**BEFORE THE  
OFFICE OF ENERGY EFFICIENCY AND RENEWABLE ENERGY  
UNITED STATES DEPARTMENT OF ENERGY  
WASHINGTON, DC**

<b>Energy Conservation Program</b>	)	
<b>for Consumer Products:</b>	)	<b>Docket No. EERE-2014-BT-STD-0031</b>
<b>Energy Conservation Standards</b>	)	<b>RIN 1905-AD20</b>
<b>For Residential Furnaces</b>	)

**SOUTHERN CALIFORNIA GAS (SoCalGas®) COMMENTS:**

Figure 1: Commented distribution of residential gas furnaces by efficiency

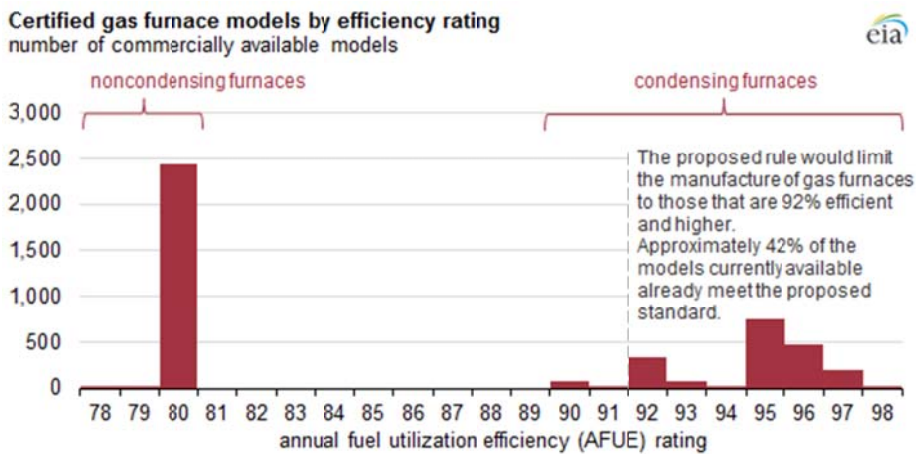
- 1) Government intervention is unnecessary. The condensing furnace market has moved substantially toward the proposed 92% AFUE level without it being mandated by the standard.<sup>1</sup> The chart below shows that more than 50 percent of gas furnaces on the national market are already above 90% AFUE, 42 percent of which are above 92% AFUE (U.S. Energy Information Administration, Proposed efficiency standards may eliminate noncondensing gas furnaces, 2015). These data support the position that the standard is not needed. Simply put, where the higher efficiencies make economic sense, they are already being adopted by consumers.

Figure 3: Natural Gas Price Outlook, AEO2014 vs. AEO2015

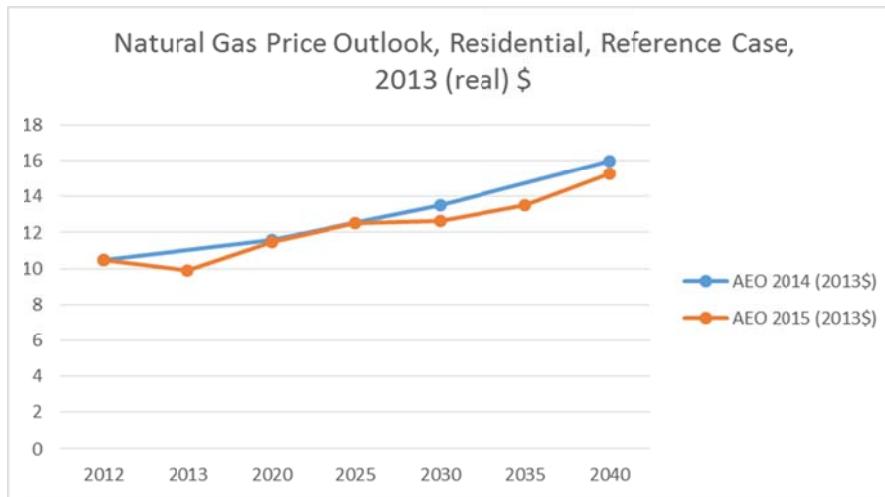
9) Price Forecasts: DOE's use of price forecasts for energy prices may be outdated.<sup>16, 17</sup> The DOE uses the AEO 2014 (U.S. Energy Information Administration, American Energy Outlook, 2014). In comparison, AEO 2015 (U.S. Energy Information Administration, American Energy Outlook, 2015) anticipates about 4.5% lower natural gas prices than AEO 2014 in real 2013 dollars, by 2040. So the LCC savings that DOE estimated using AEO 2014 would be reduced and payback times for the 92% AFUE condensing furnace would increase accordingly.

Figure 4: Natural Gas Price Outlook, AEO 2015 vs. CEC 2014 (non-normalized draft)

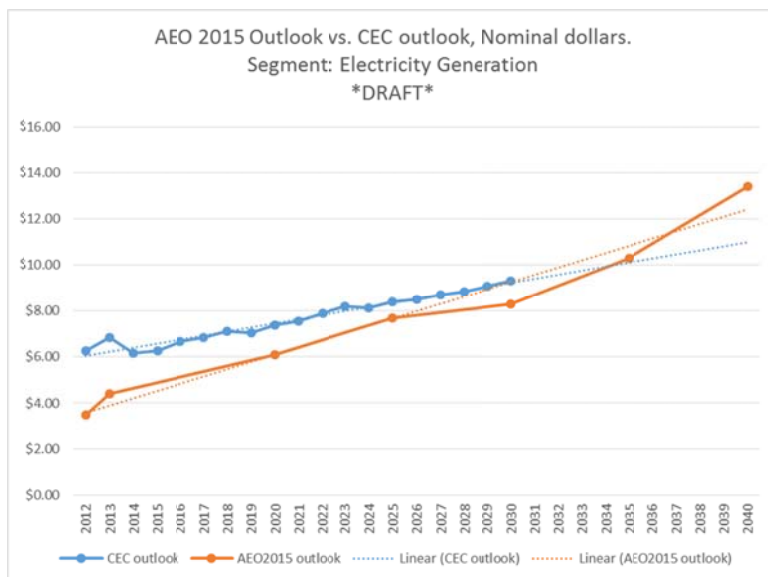
Using AEO forecasts may not be appropriate for California.<sup>18</sup> The chart below shows that AEO 2015 (U.S. Energy Information Administration, American Energy Outlook, 2015) estimates that prices will *rise faster* than what the CEC forecasts for California (California Energy Commission, 2014). Note that the trends from this chart should be interpreted qualitatively at this time (hence the chart label “Draft”). The chart's figures are not normalized at this time, and require conversion from nominal to real dollars, as well as subtraction of transportation cost from the CEC outlook. The fact that AEO predicts a higher rise than CEC should not be affected by these corrections. LCC Savings are reduced and payback times increased if natural gas prices don't rise as fast in reality as the DOE assumes.
